ADDENDUM # 3

RFP # 7550284

**TITLE: AUDIO VISUAL CHEMISTRY AND FORENSIC SCIENCE CENTER,
UNIVERSITY OF RHODE ISLAND**

University of Rhode Island
Audio / Visual Package
New Center for Chemistry & Forensic Science
Kingston, Rhode Island

Scale NTS
Date 03/15/15
Number SKAV-02

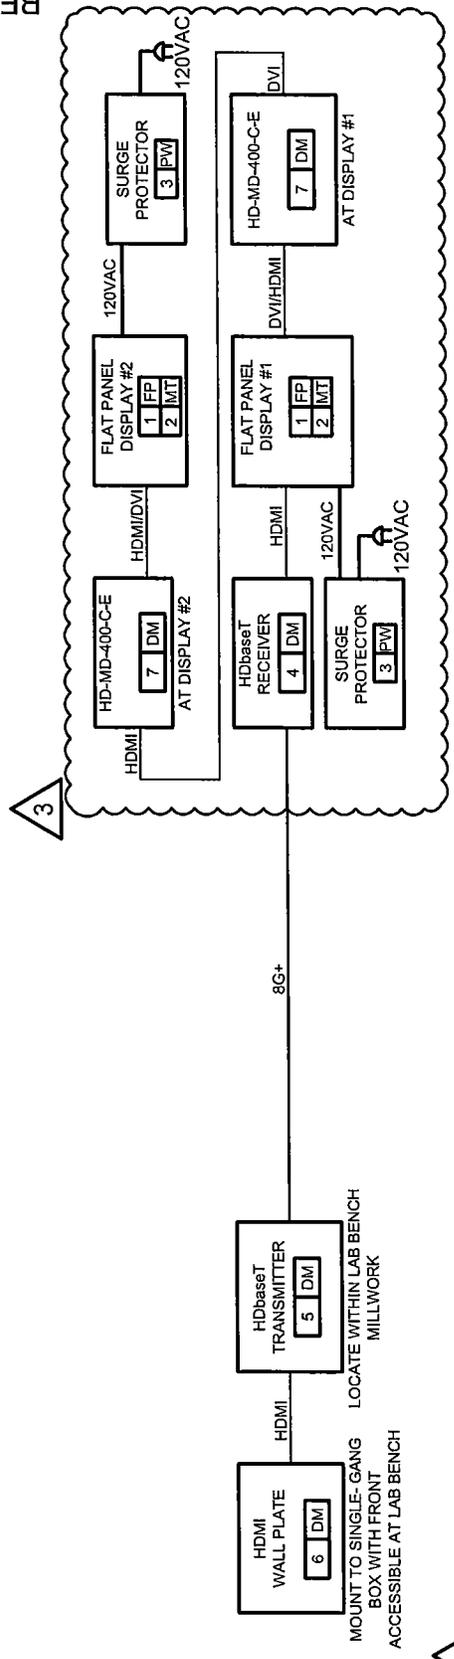
AV-304 – Audio Visual Details Sheet – Revise the AV Signal Flow Schedule/Diagram for the Teaching Labs. See attached Sketch SKAV-02 dated 03.15.16.

9. First floor teaching lab spaces show two 65" displays on the floor plans however the signal flow diagram includes on one. Confirm one is required.

Response: (2) Two TVs will be installed per AV 121. REFER TO SKETCH SKAV-02, ATTACHED TO AND MADE PART OF THIS ADDENDUM, WITH UPDATED SIGNAL FLOW AND EQUIPMENT LIST. TVs PURCHASED MUST HAVE A HDMI/DVI OUTPUT AS 2ND MONITOR WILL BE CLONE OF 1ST MONITOR.
